# Truro Zoning Board of Appeals Agenda

## STAFF MEMORANDUM

### **22 Highland Road, Cloverleaf Truro Rental Housing: Notice of Project Change**

## NOTICE OF PROJECT CHANGE

**1** BLDG 2-4-6-8 - EAST ELEVATION  
SCALE: 1/8" = 1'-0"

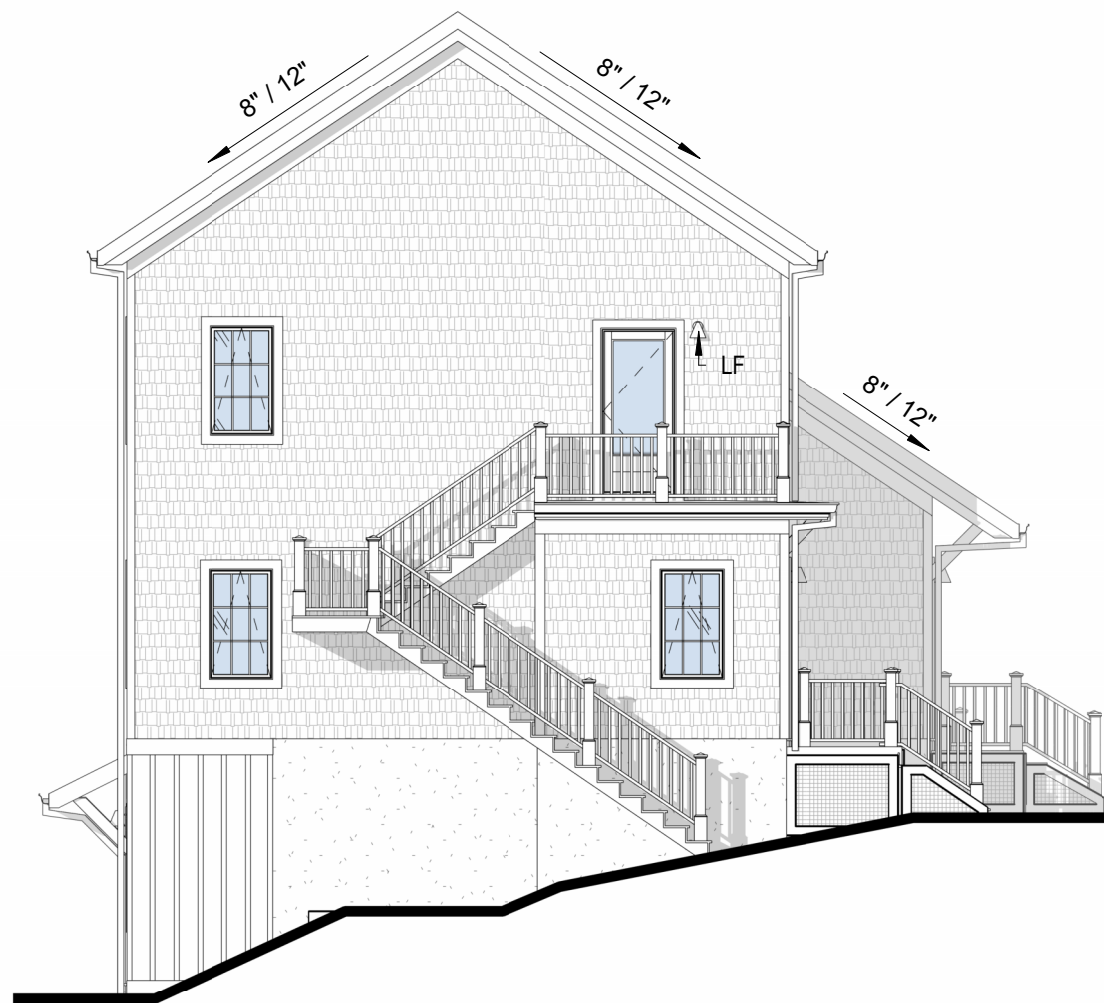
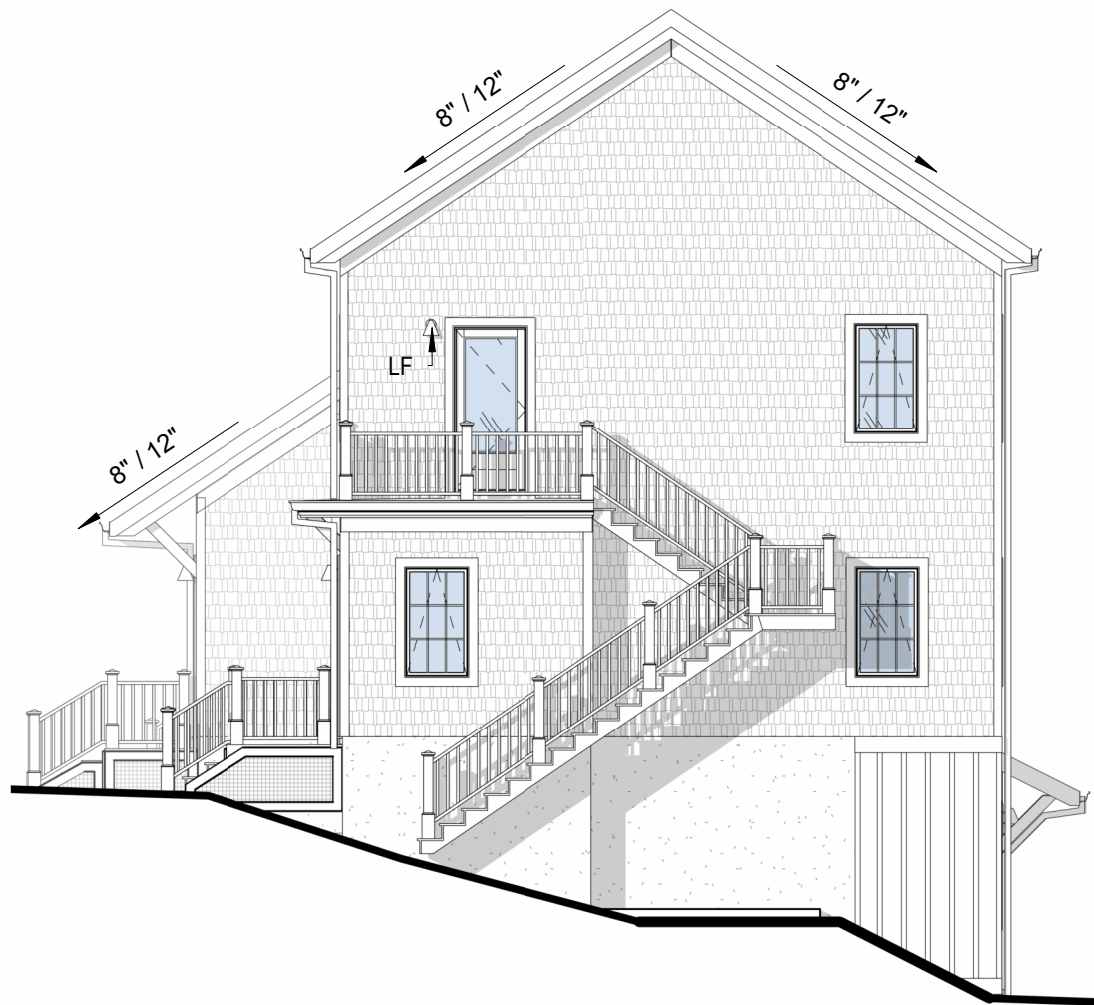
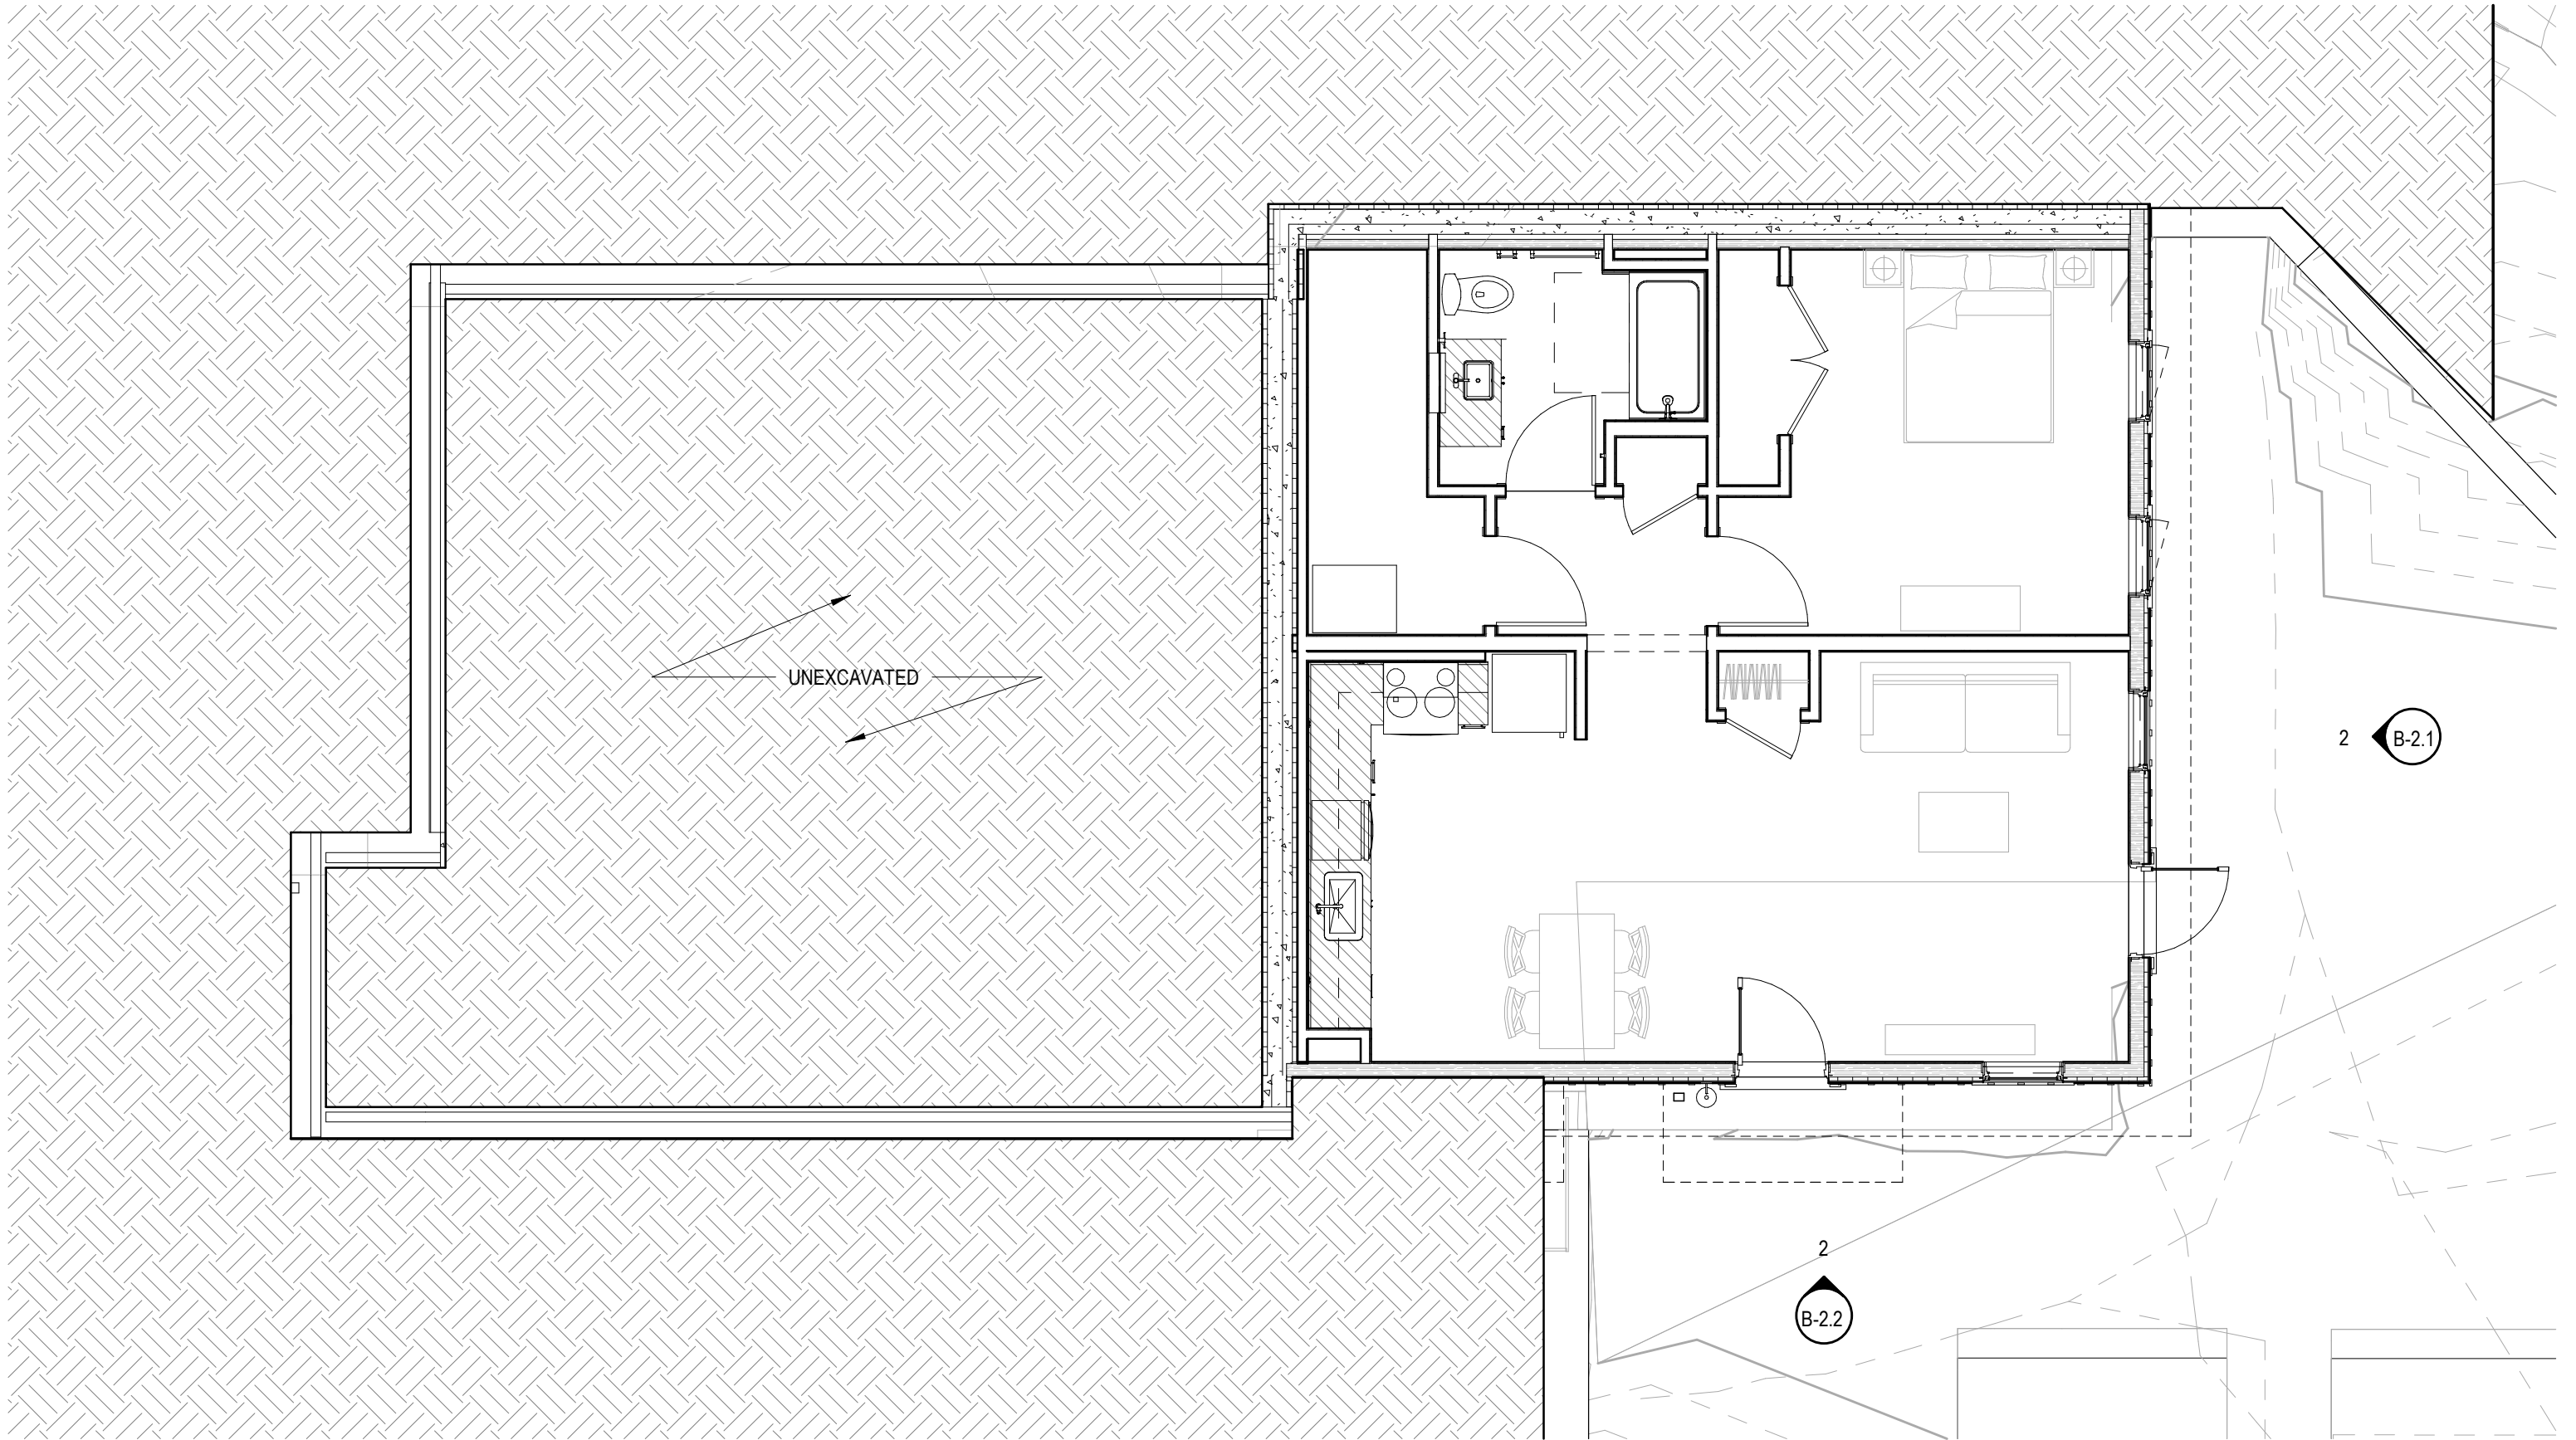
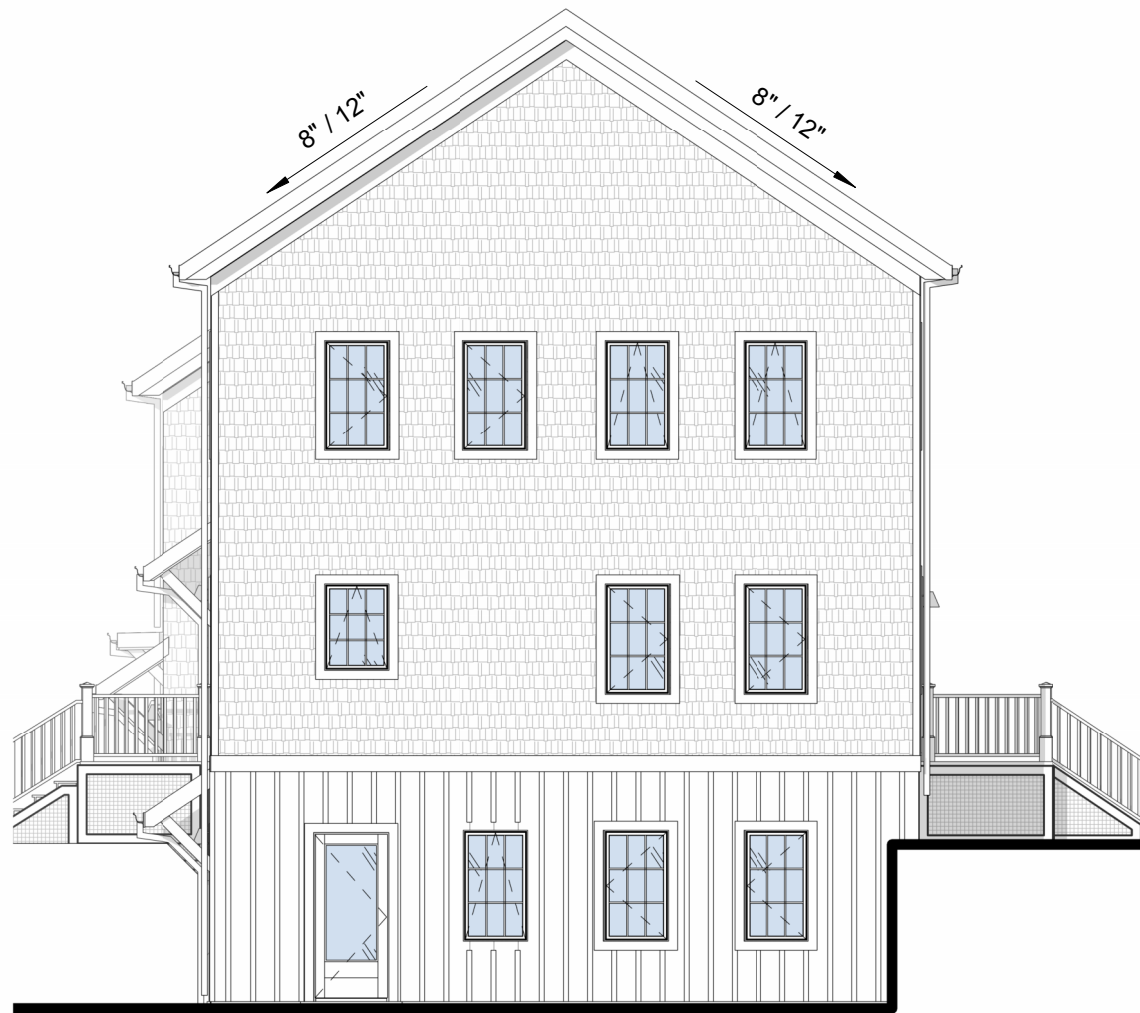
The plan set in the application includes elevations of Building 1-7 and 2-8, but the height of these buildings is not indicated.

The Notice of Project Change also includes charts pertaining to grade and building height, existing and proposed, for Buildings 1-7 and 2-8. These indicate decreases in average grade (from existing to proposed), and increases in building height above average grade (from existing to proposed). The Applicant or project engineer may be asked to explain the grade changes and their effect on the height of these buildings. If the resulting height of either building exceeds the Bylaw maximum of 30 feet, a waiver by the Board would be required. The specific finished height of the building(s) and the specific waiver in feet/inches should be indicated.

If it is determined that there is an increase in the height of Building 1-7 or 2-6, and if so whether there is "[a]n increase of more than 10% in the height of the building(s)," the Board would again have discretion in making its determination of substantial/insubstantial change. See 760 CMR 56.07(4)(c)(1).

"The Building Height as measured for existing grade has been recalculated based on the existing grade elevations at the proposed corners of the combined building 1-3-5-7 and 2- 4-6-8. There is no change to the building height as previously proposed."

**Vice Chair Shedd seconded the motion.**

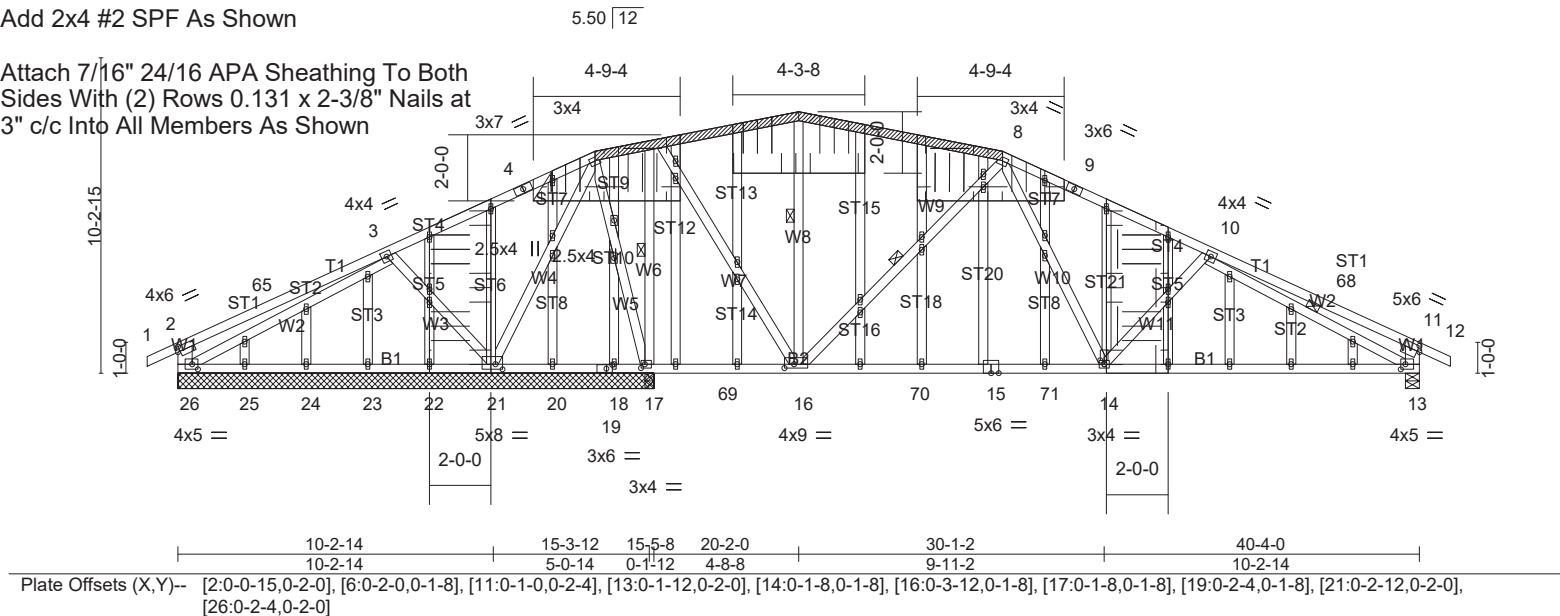
Due to questions raised by an abutter regarding the finished height of the dwelling, the Building Commissioner required that the as-built height be certified by a registered engineer. The result: a height 1' 6" in excess of the Zoning Bylaw maximum of 30 feet. See Narrative at p.1. By way of explanation, the applicant states that while he had identified the roof truss height as an

issue during design, his modification to the design (lowering the roof pitch) was not received by the truss designer. The too-tall trusses were installed, resulting in the ridge height in excess of the Bylaw maximum. See narrative at p. 1
